Contract #: 04-0120F4Cty: SF/ALA Rte: 80 PM: 13.2/13.9File #: xx.25B**QUALITY ASSURANCE -- NON-CONFORMANCE REPORT****Location:** Changxing Island, Shanghai, China**Report No:** NCR-000860**Prime Contractor:** American Bridge/Fluor Enterprises, a JV**Date:** 11-Oct-2010**Submitting Contractor:** Zhenhua Port Machinery Company, Ltd (ZPMC), Changxing Island**NCR #:** ZPMC-0822**Type of problem:****Welding****Concrete****Other****Welding****Curing****Procedural****Bridge No:** 34-0006**Joint fit-up****Coating****Other****Component:** FB3286A, SA8003 Lift 14E**Procedural****Procedural****Description:****Reference Description:** Base Metal Repair without Prior Approval from Engineer**Description of Non-Conformance:**

Job Name: SAS Superstructure

Subject: NCR No. ZPMC-0822

Reference Description: Base Metal Repair without Prior Approval from Engineer

Component: FB3286A, Lift 14E

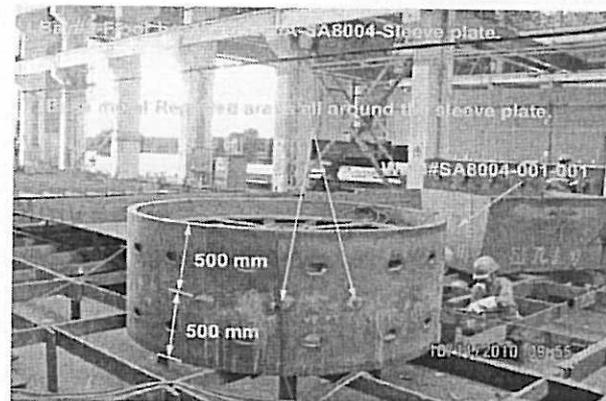
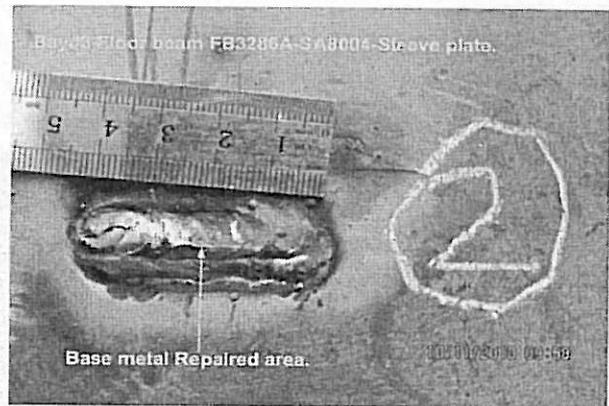
During Quality Assurance random in-process observations of the fabrication of OBG lift 14E, East Floor beam FB3286A, this Quality Assurance Inspector (QA) discovered the following issue:

- ZPMC Welding personnel performed base metal repair (BMR) on the sleeve plate without the Engineers approval.
- Total of 7 areas repaired.
- The welding was performed using Shielded Metal Arc Welding (SMAW) in the Horizontal (2G) position.
- The sleeve plate is identified as SA8004.
- The Y locations are approximately 410 mm, 1375 mm, 1810 mm, 3750 mm, 4630 mm, 5120 mm and 7180 mm from the toe of the weld identified as SA8004-001-001 (measured clock wise and looking from top of the sleeve).
- FB3286A – SA8004 is located in the Sub assembly Bay#3.

Component: FB3286A, SA8003 Lift 14E

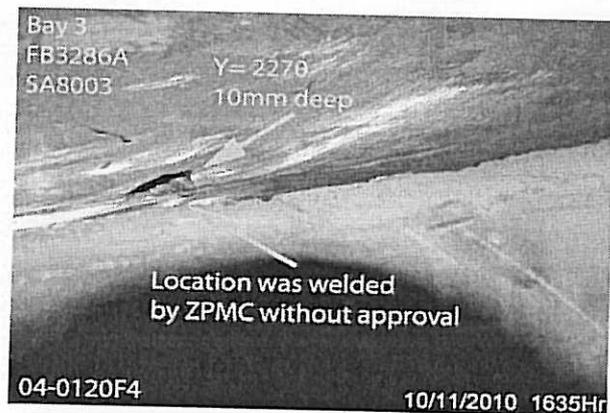
-ZPMC Welding personnel performed base metal repair (BMR) on the sleeve plate without the Engineers approval.

- Total of 2 areas repaired.

-The welding was performed using Shielded Metal Arc Welding (SMAW) in the Horizontal (2G) position.

-The sleeve plate is identified as SA8003.

-The Y locations are approximately 2270 mm and 5150mm from the toe of the weld identified as SA8003-001-001 (measured clock wise and looking from top of the sleeve).

Draft of welding discontinuity:

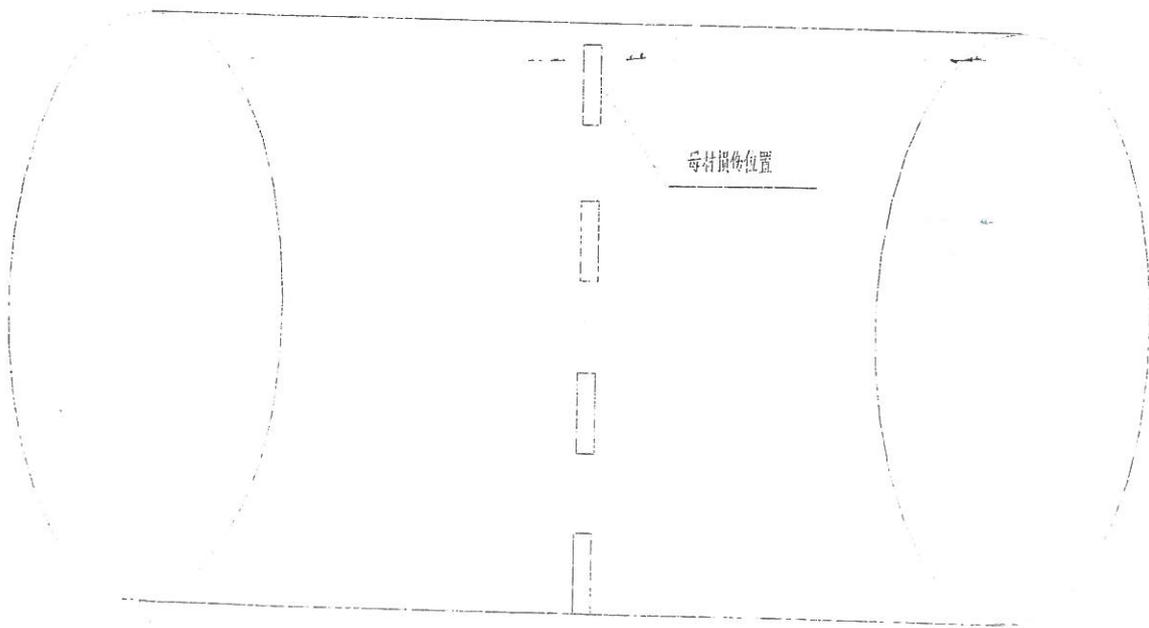
When removing tack weld of SA8003(X8005A/X8006A)、SA8004(X8005B/X8006B), base metal was damaged by 10mm due to incorrect gouging, which need repairing. Please see the details in the following sketch.

1. QC and CWI should be present to witness the repair, direct and supervise all repair operations during this repair to ensure the repair is per the disposition requirements, and the AWS D1.5 code requirements.
2. Grind the repair area to a smooth finish according to the approved repair WPS.
3. Prepare the joint according to the approved WPS.
4. Notify QA verbally prior to NDT. Perform 100%MT and 100%VT of the repair area.
5. Remove all defects by grinding to ensure all defects are completely removed if defects still exist, and repeat "step 4" to assure complete removal of all defects if necessary.
6. Clean the repair area of all loose debris including MT powder.
7. Preheat and weld according to the approved WPS.
8. Grind the weld flush after welding.
9. Notify QA verbally prior to NDT. Perform 100%MT and 100%VT of the repair area.
